MANCHESTER TOWNSHIP PLANNING COMMISSION AGENDA WEDNESDAY JULY 29, 2026— 6:00 PM

RVW # 2026-07- 1345 Mill Creek Road- Frederick Fogelman and Teresa Shultz
Fogelman- Final Minor Subdivision Plan

Re: Responses to Comments on the
Final Minor Subdivision Plan
Fredrick Fogelman and Teresa Shultz Fogelman
1345 Mill Creek Road
York, PA 17404
SDC Job #: 1666.1

Re: Fogelman (1345 Millcreek Rd.) Minor Subdivision Plan
Manchester Township Plan #2026-07
Engineer's Project No. 0841.3.16.72

SCALE		AS NOTED
DRAWN BY		JMB
CHECKED BY		RMH/ARB
CONTACT		JCP
DATE		05.04.26
FILE NAME		
1666.1-FSD-1		
JOB NO.		
1666.1		
SHEET NO.		REV.
FSD-6 SHT. OF 6		2

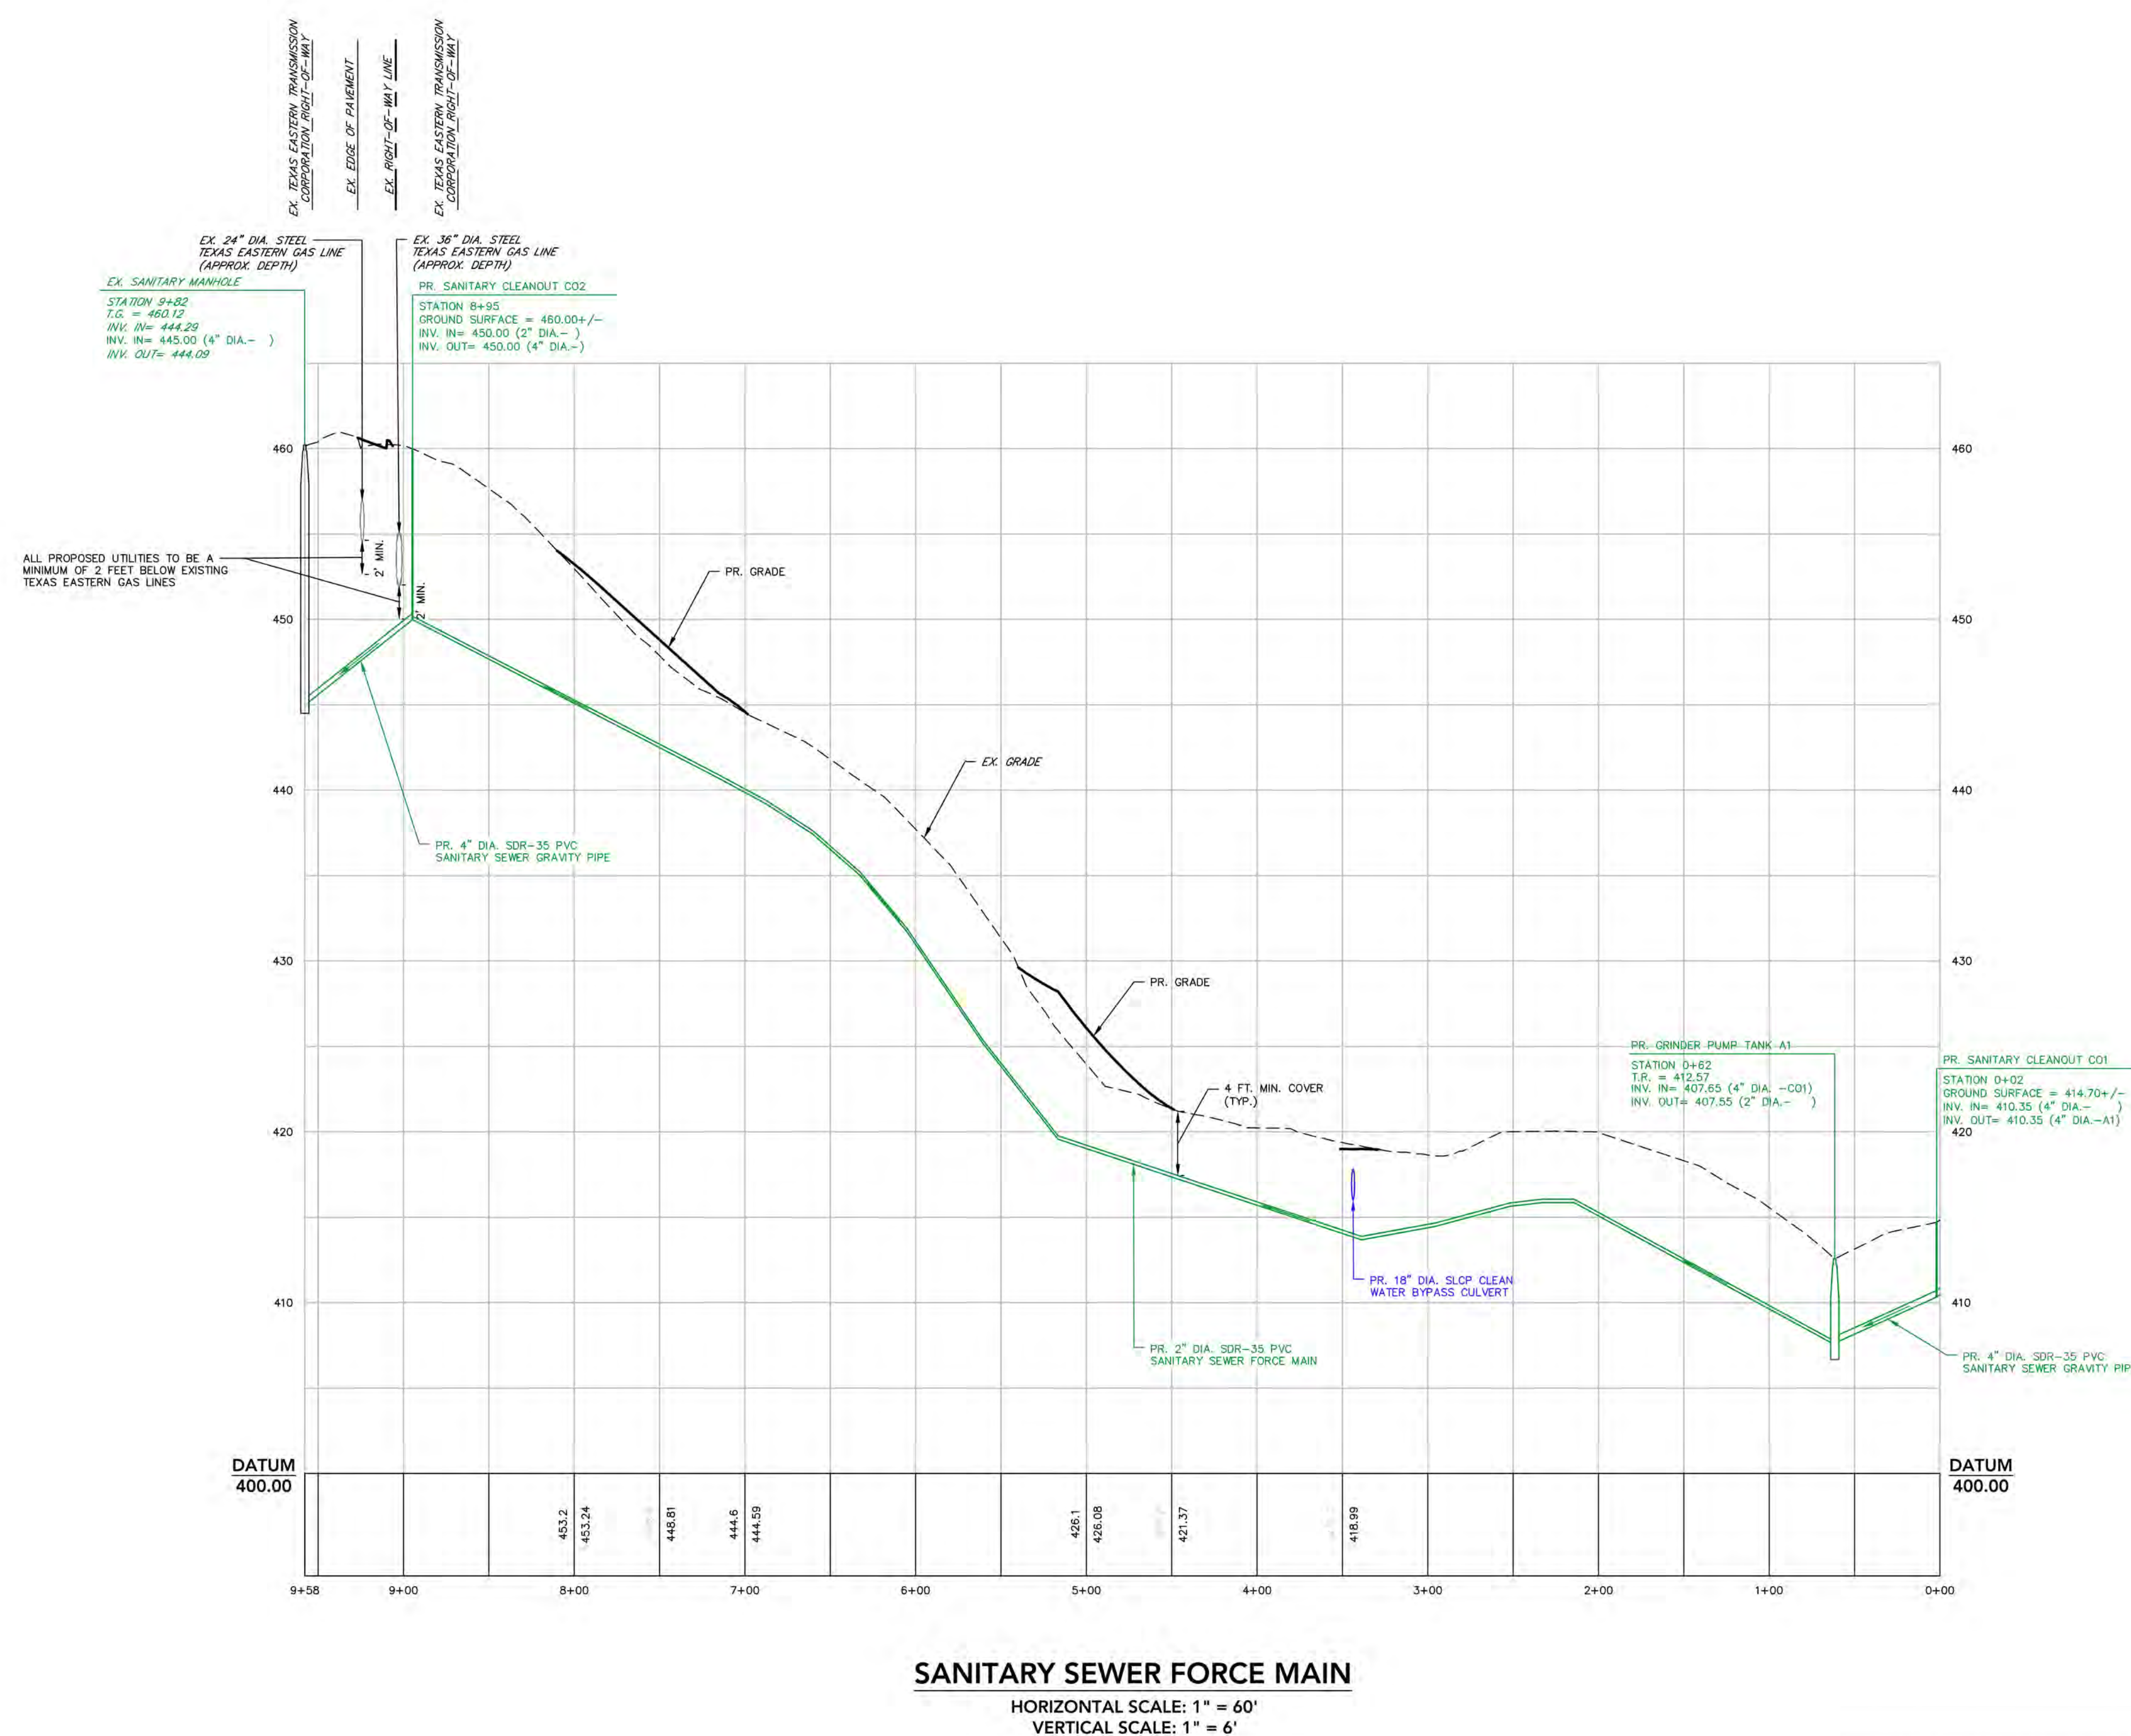
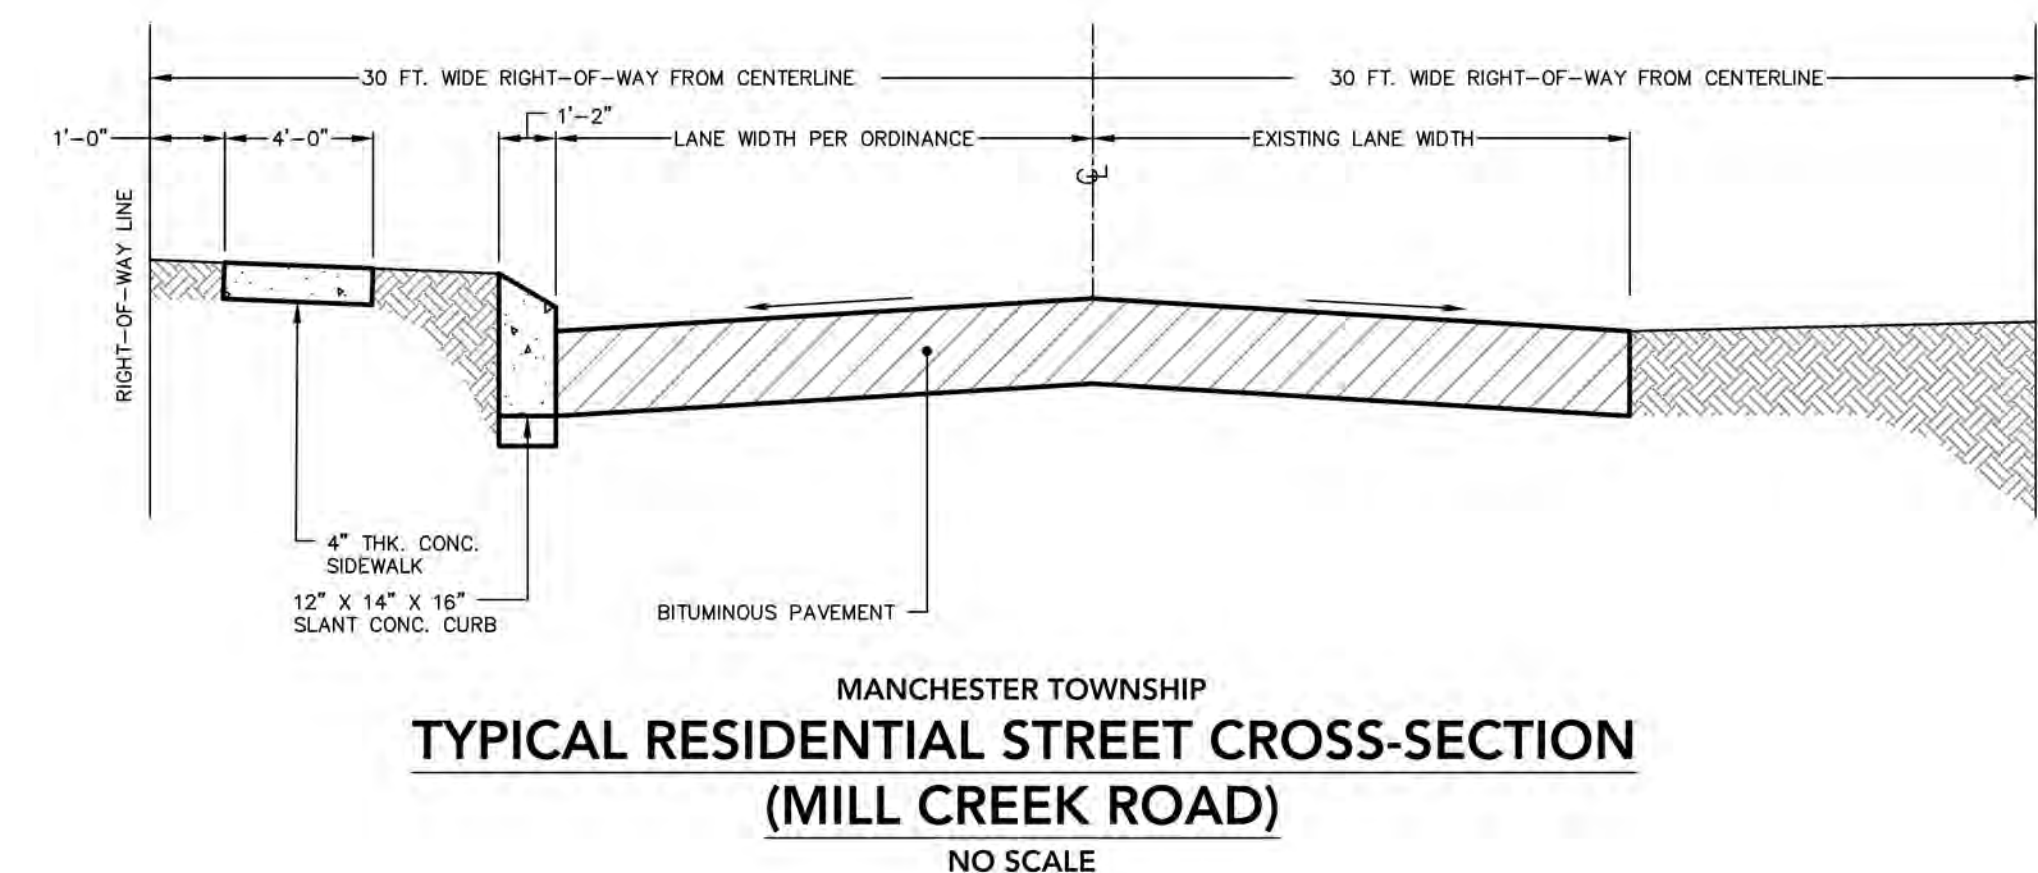
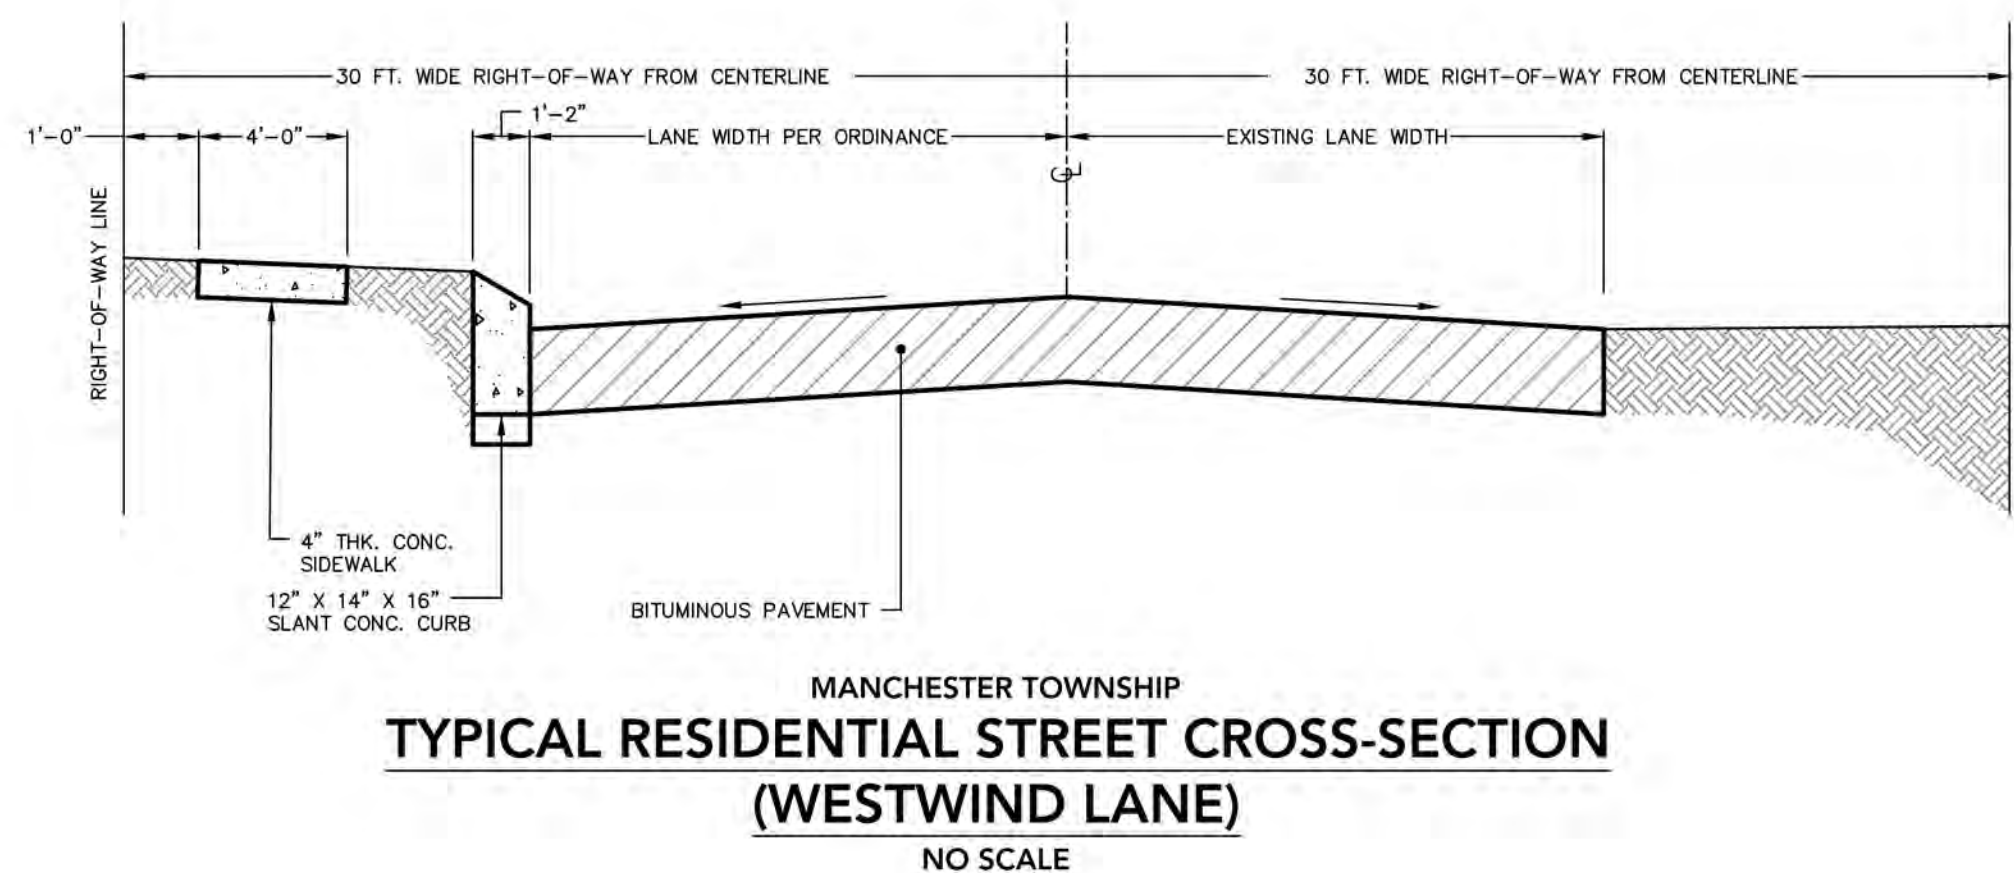
6. Required and proposed safe stopping sight distance calculations shall be provided on the plans for any existing and proposed driveway/access drive. (§22-404.4.30) **Sight distance (right) is less than required on Mill Creek Rd. Can driveway be relocated to accommodate safe sight distance?**

6. Safe sight stopping distance measurements have been completed for the existing and proposed driveway locations. Refer to Plan Sheet FSD-6. The sight distance for the existing driveway accessing Mill Creek Road being less than the required distance is a preexisting nonconformity, and there is no intention to relocate the driveway at this time. The driveway and barn have existed this way since at least 1993 per Google Earth imagery, and the previous owner has not expressed any issues with this driveway during his ownership of the property.
